<b>EASA</b>	<b>AIRWORTHINESS DIRECTIVE</b>
	<p><b>AD No.: 2014-0018</b></p> <p><b>Date: 16 January 2014</b></p> <p>Note: This Airworthiness Directive (AD) is issued by EASA, acting in accordance with Regulation (EC) No 216/2008 on behalf of the European Community, its Member States and of the European third countries that participate in the activities of EASA under Article 66 of that Regulation.</p>
<p>This AD is issued in accordance with EU 748/2012, Part 21.A.3B. In accordance with EC 2042/2003 Annex I, Part M.A.301, the continuing airworthiness of an aircraft shall be ensured by accomplishing any applicable ADs. Consequently, no person may operate an aircraft to which an AD applies, except in accordance with the requirements of that AD, unless otherwise specified by the Agency [EC 2042/2003 Annex I, Part M.A.303] or agreed with the Authority of the State of Registry [EC 216/2008, Article 14(4) exemption].</p>

<p><b>Design Approval Holder's Name :</b></p> <p>AIRBUS</p>	<p><b>Type/Model designation(s) :</b></p> <p>A300, A300-600, A300-600ST and A310 aeroplanes</p>
<p>TCDS Numbers : France No. 145 and EASA.A.014</p>	
<p>Foreign AD : None</p>	
<p>Supersedure : This AD supersedes EA

**Appendix 1**

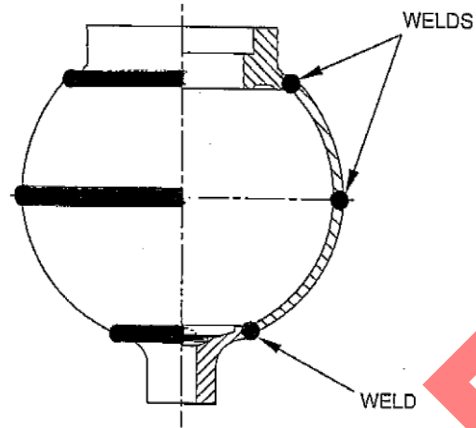
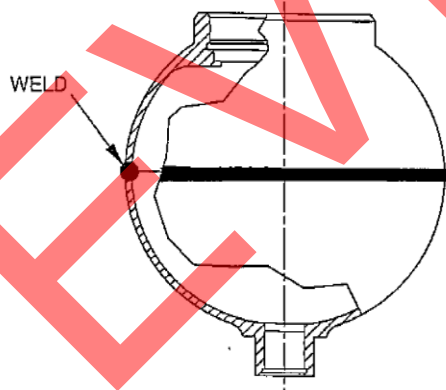
**HYDRAULIC ACCUMULATOR** : designed with 4 parts and 3 welds

**HYDRAULIC ACCUMULATOR** : designed with 2 parts and 1 weld

<p>(1.2) If, during the visual inspection as required by paragraph (1.1) of this AD, an old design hydraulic accumulator is found installed on any of the affected hydraulic circuits as indicated in Table 1 of this AD, as applicable to aeroplane model, replace each affected old design accumulator with a new design accumulator in accordance with the instructions of Airbus SB A300-29-0126 Revision 01, SB A310-29-2099, SB A300-29-6063, or SB A300-29-9012, as applicable to aeroplane model.</p> <p><b>New requirements of this AD:</b></p> <p>(1.3) Irrespective of findings during the visual inspection as required by paragraph (1.1) of this AD, install placards at the designated locations of the affected hydraulic circuits indicated in Table 1 of this AD, as applicable to aeroplane model, in accordance with the instructions of Airbus SB A300-29-0127 Revision 01, SB A310-29-2100 Revision 01, SB A300-29-6064 Revision 01, or SB A300-29-9013 Revision 01, as applicable to aeroplane model.</p>	Affected aeroplanes	Affected hydraulic circuit(s)	A300, without Airbus Modification (Mod) 02447 embodied in production	Blue and Green	A300, with Airbus Mod 02447 embodied in production	Blue	A300-600 and A300F4-608ST	A310	Green
Affected aeroplanes	Affected hydraulic circuit(s)									
A300, without Airbus Modification (Mod) 02447 embodied in production	Blue and Green									
A300, with Airbus Mod 02447 embodied in production	Blue									
A300-600 and A300F4-608ST										
A310	Green
